APPLICATION NO.	FILING DATE	FIRST NAMED INVENTOR	ATTORNEY DOCKET NO.	CONFIRMATION NO.
10/085,204	02/26/2002	Takuro Sekiya	220103US2	8688
22850	7590	07/28/2004	EXAMINER	
OBLON, SPIVAK, MCCLELLAND, MAIER & NEUSTADT, P.C. 1940 DUKE STREET ALEXANDRIA, VA 22314			MENEFE, JAMES A	
			ART UNIT	PAPER NUMBER
			2828

Office Action Summary

DETAILED ACTION

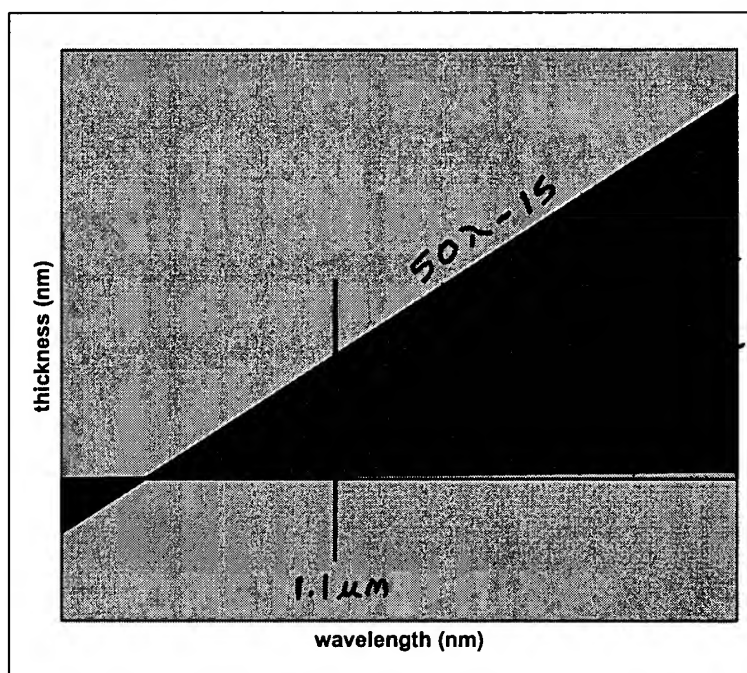
Applicant argued that claim 6 is distinguishable from Ohiso because claim 6 requires the thickness to fulfill a linear relationship (i.e. $y = mx + b$). However, applicant's argument is incorrect. The claim only requires a thickness $< 50\lambda - 15$. This does not require a linear relationship to hold between the thickness and the wavelength. This wording of the claim only requires the thickness to fall below the $50\lambda - 15$ line. For example, see the graph on the following page. Ohiso's thickness, as noted above in the 103 rejection, is disclosed to be less than around 95-130 nm. Even taking into account the proposed amendment to correct this

In total, the claim requires the wavelength to be greater than 1.1 microns and the thickness to be less than the $50\lambda - 15$ line. The claim does not require a linear relationship, only a thickness that falls into the hatched region of the graph above.

The examiner has a further problem with the claimed equation. Again, as noted in the 112 rejection above, it is believed that this equation is incorrect, regardless of the fact that $50\lambda - 15$ is disclosed in the specification. The applicant is mixing units in the equation, which leads to a confusing result. The examiner contends that this equation does not properly convey the intended meaning of applicant's invention. Table 2 on page 85 clearly shows the applicant's intention is for 1.1 μm wavelength to correspond to 40 nm thickness, for 1.3 μm to correspond to 50 nm, and so on. Page 85 lines 20-21 clearly state that the thickness and wavelength are to be in

These thicknesses are one thousand times the intended thicknesses listed in Table 2. Thus it is proposed that to correctly claim the invention applicant must change the equation to:

$$0.05 \lambda - 15$$

This should be changed in both the claims and in the specification. This will not be deemed new matter because it is a clarification of a clear mathematical error understood by one skilled in the art.
